SEWAGE DISPOSAL SYSTEM

HOWARD COUNTY HEALTH DEPARTMENT

A REPAIR

SITE INSPECTION SHEET

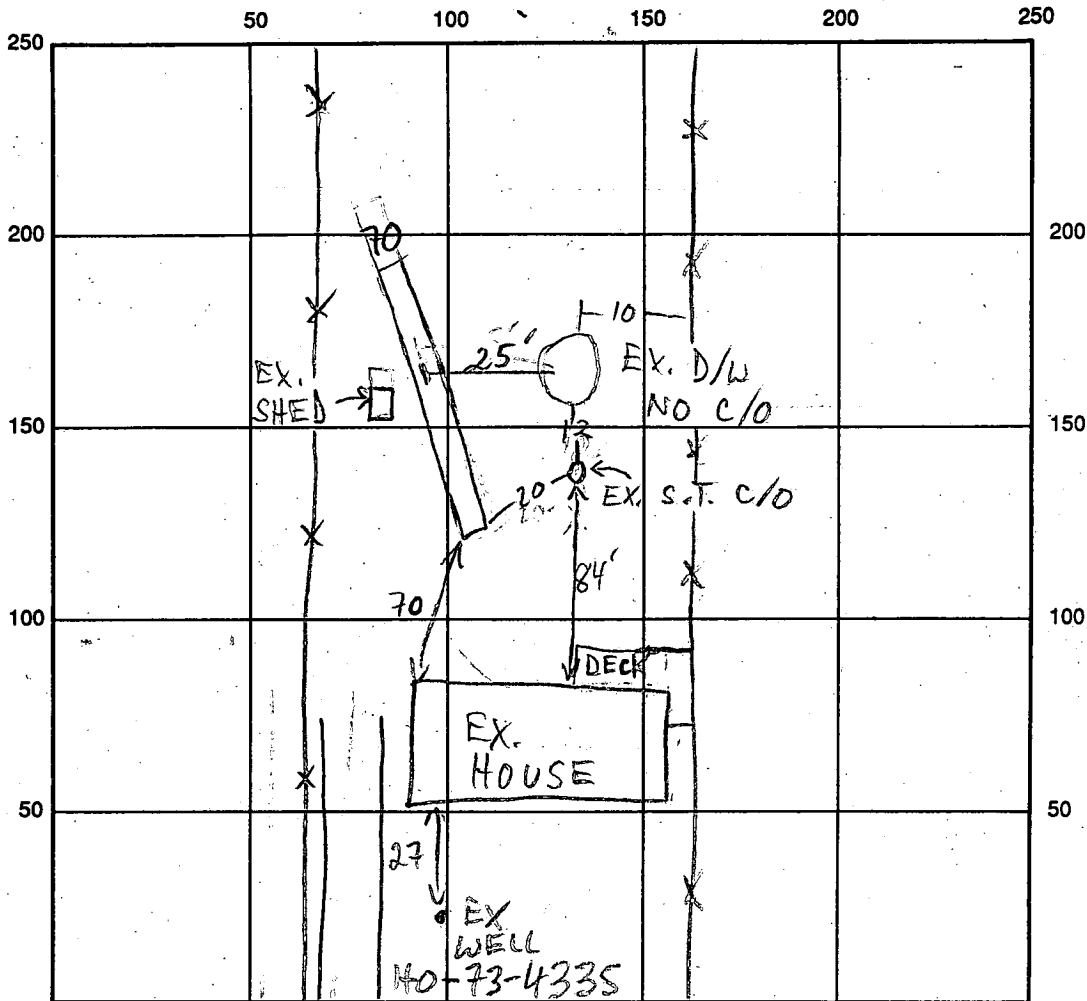
REPAIR - PURPOSE - SEPTIC SYSTEM HAS FAILED.

Call for inspection when ground is opened so sanitarian can recommend repair. 08/11/93

INLET 3 1/2', BOT 9', 6 1/2' STONE MR

REMARKS: 8/12/93 OK TO COVER MR

LOCATION DIAGRAM

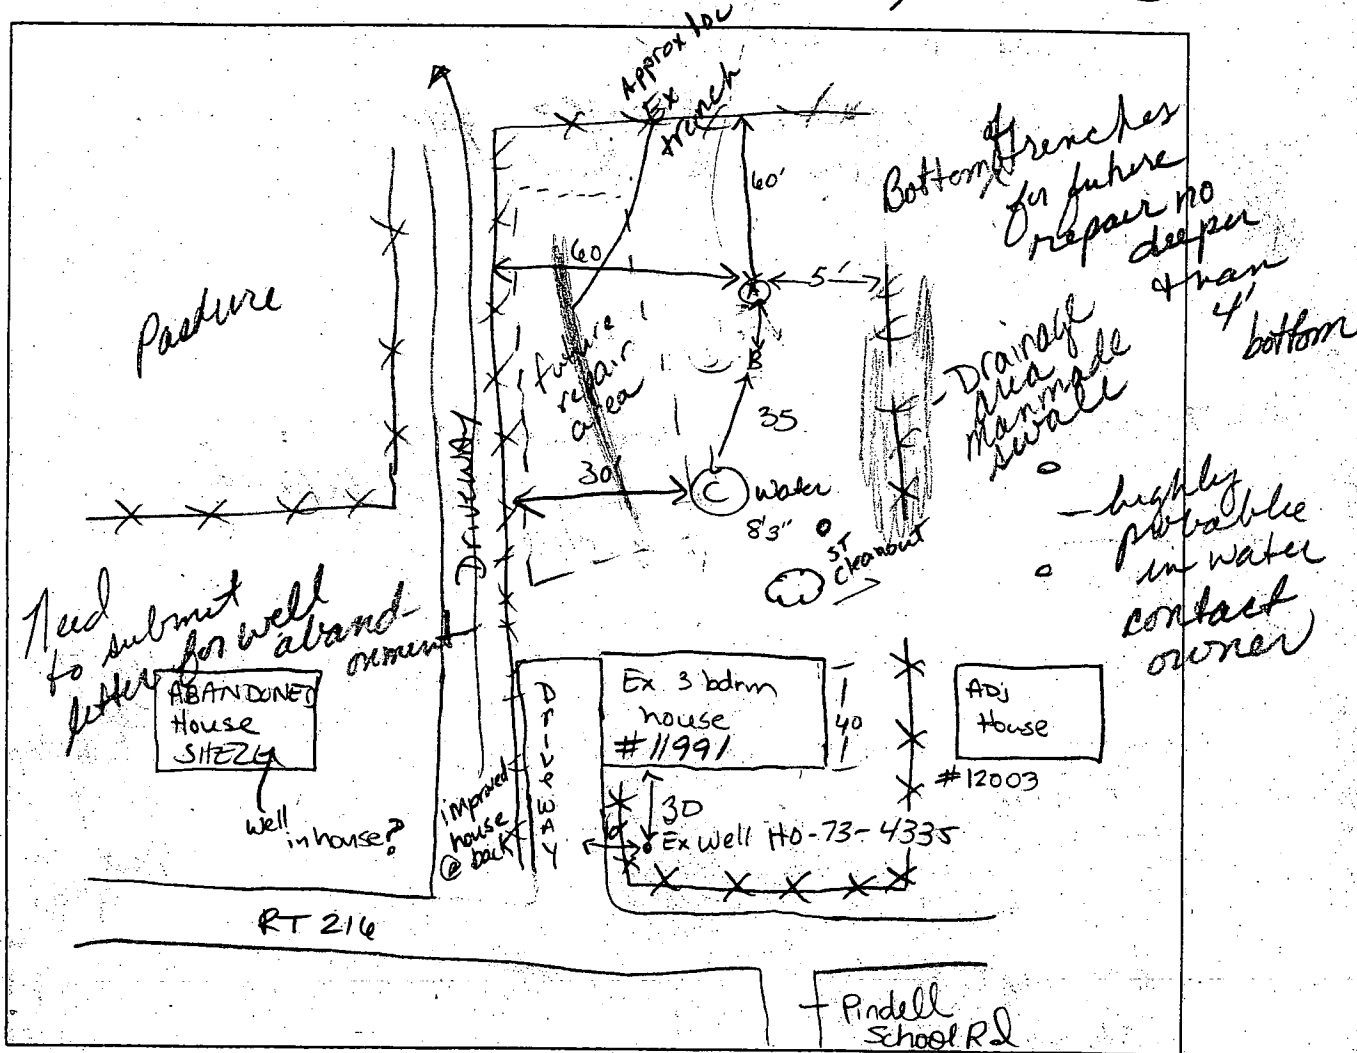
PROPOSAL: 8/25/04 Possible buyer wants to know if 30x40
garage permit would be approved prior to prop.
purchase

COMMENTS: 8/25/04 See soil descriptions on back. Due to
lack of area & considering soil descriptions,
highest area on east side of prop only area
avail for septic repair. Building permits for

additional buildings not approvable until further
testing/back hoe on site for excavation.

LOCATION DIAGRAM

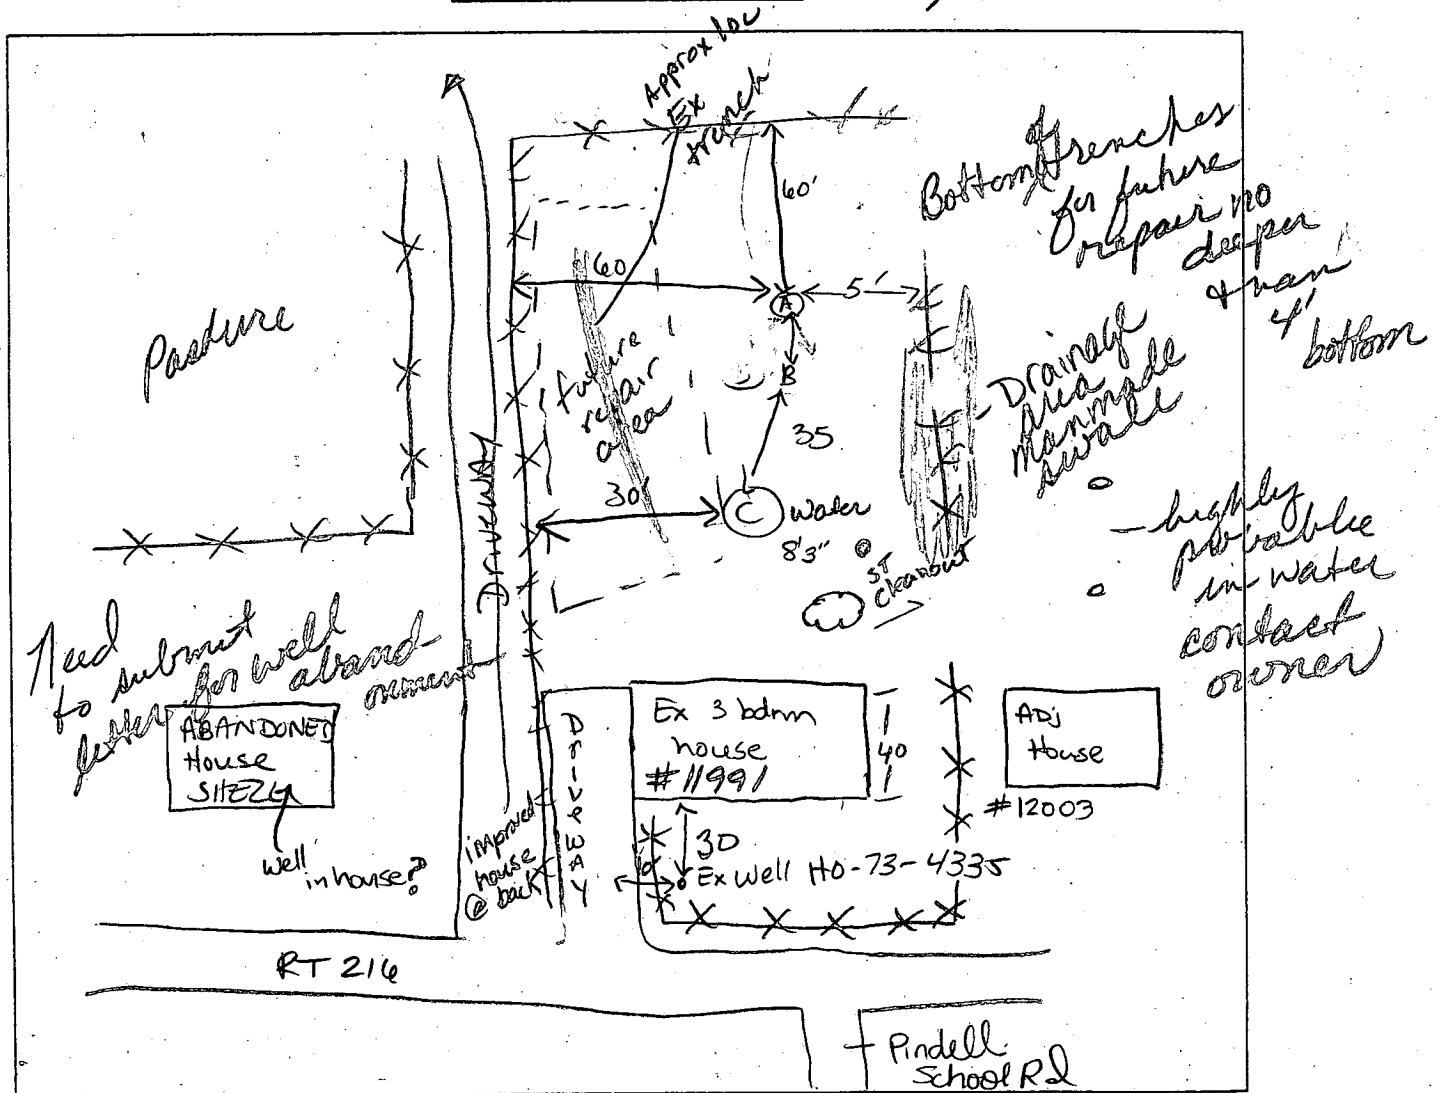
PROPOSAL: 8/25/04 Possible buyer wants to know if 30x40
garage permit would be approved prior to prop.
purchase

COMMENTS: 8/25/04 See soil descriptions on back. Due to
lack of area & considering soil descriptions,
highest area on east side of prop. only area
avail for septic repair. Building permits for
 DATE: 8/25/04 INSPECTOR: KN / PJ

additional buildings not approvable until further
testing/backhoe on site for excavation.
